ORIGINATION FORM

Proposed Revisions to a Standard Plans Index (Please provide all information — Incomplete forms will be returned)

Index Number: 700-020
Sheet Number (s): 1 of 3
Index Title: Multi-Column Ground Sign

Summary of the changes:

SHEET
1 of 3

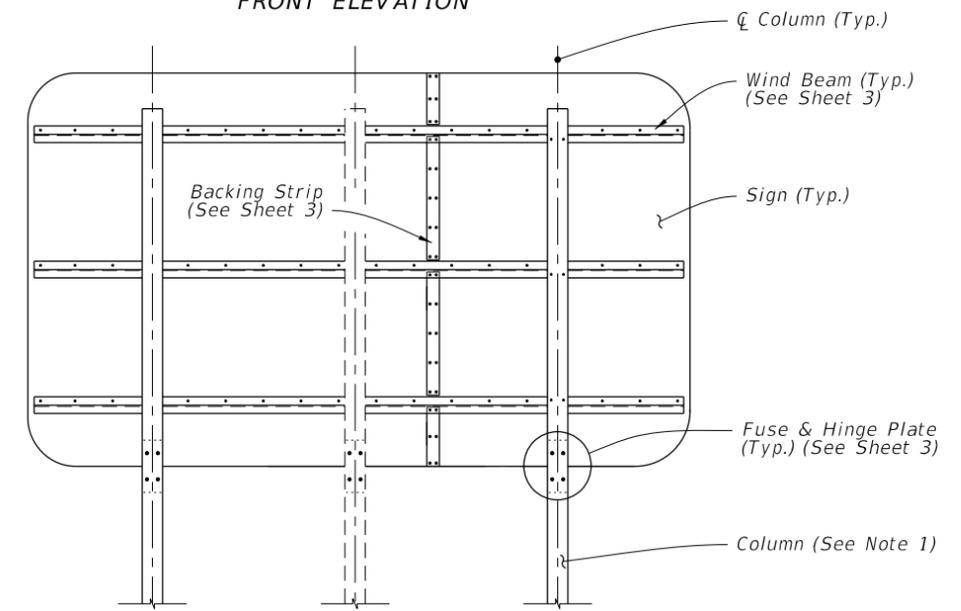
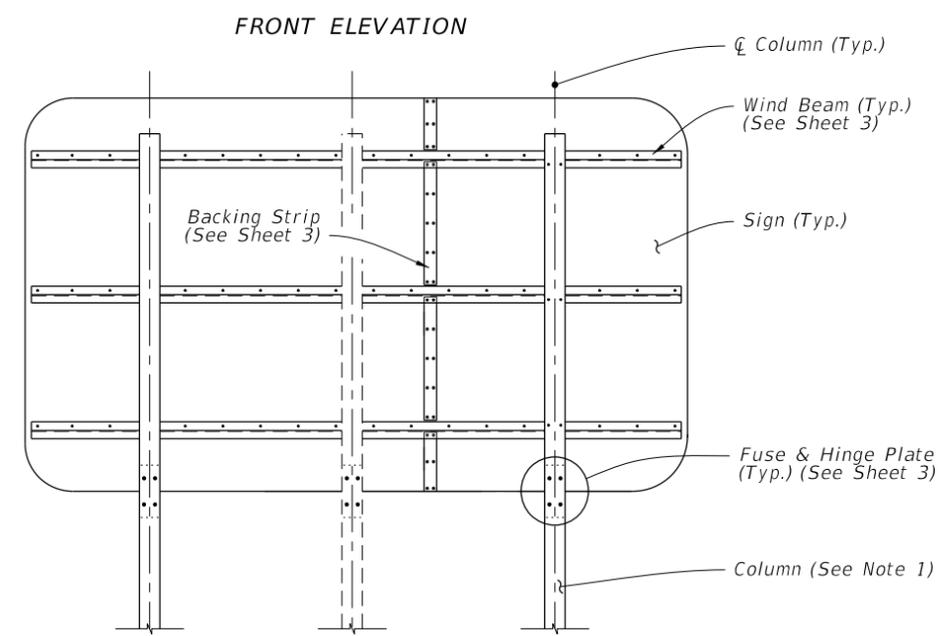
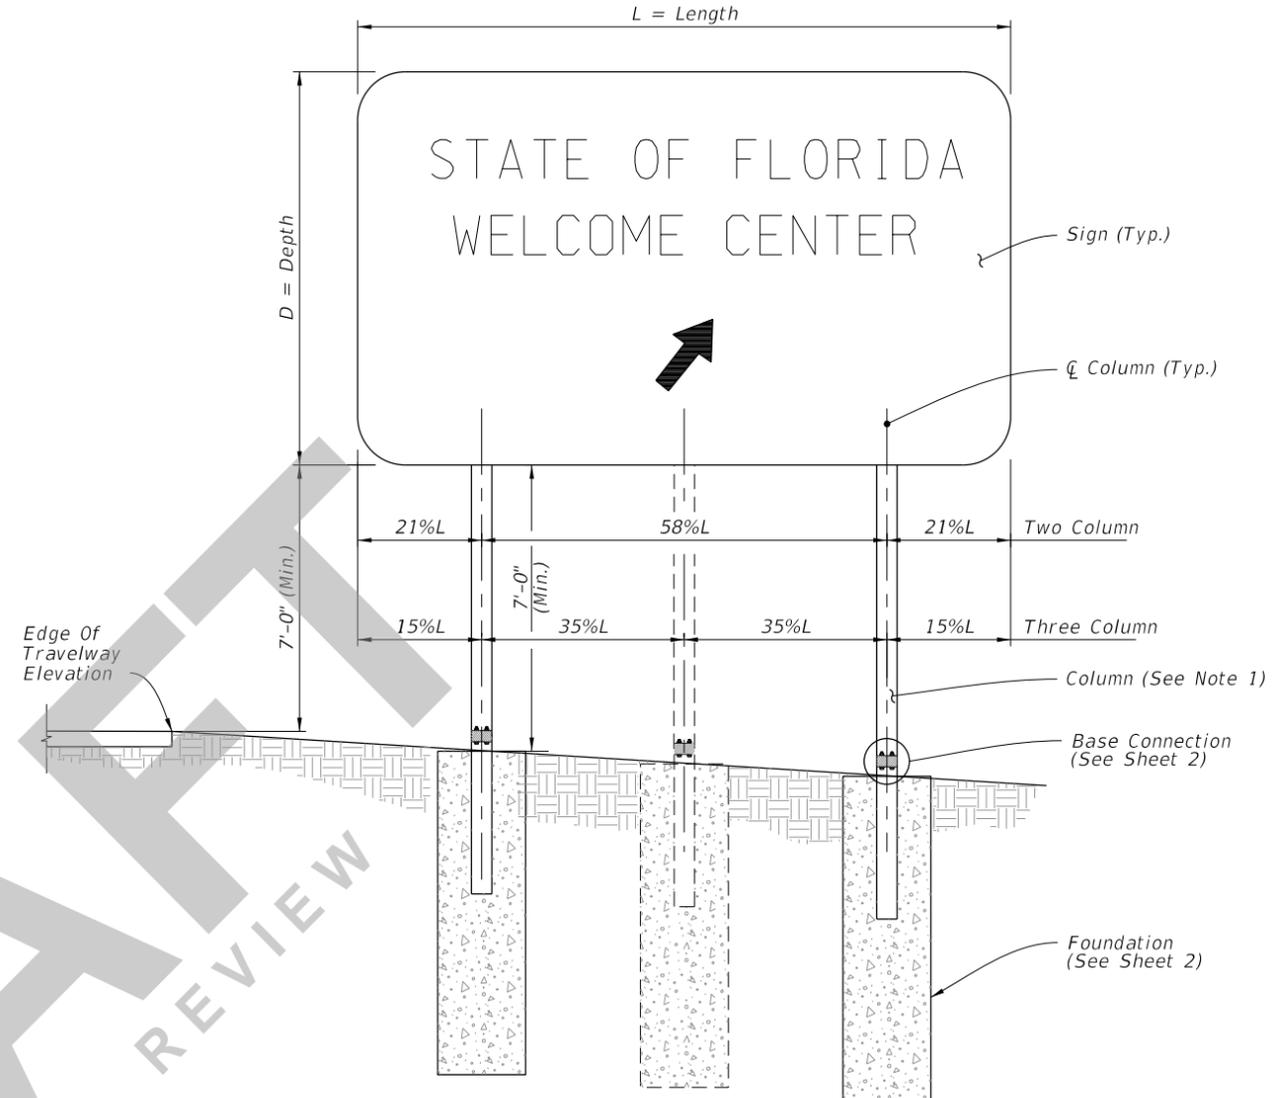
Sheet 1: Change Note 3.A.b reference to ASTM B308 to ASTM B221 throughout Standard Plans as an administrative change.

- b. Aluminum Structural Shapes: ASTM B308, Alloy 6061-T6
 - B. Sign Support Structure Materials:
 - a. Steel Plates and Structural Shapes: ASTM A36 or ASTM A709, Grade 36

- b. Aluminum Structural Shapes: ASTM B221, Alloy 6061-T6
 - B. Sign Support Structure Materials:
 - a. Steel Plates and Structural Shapes: ASTM A36 or ASTM A709, Grade 36
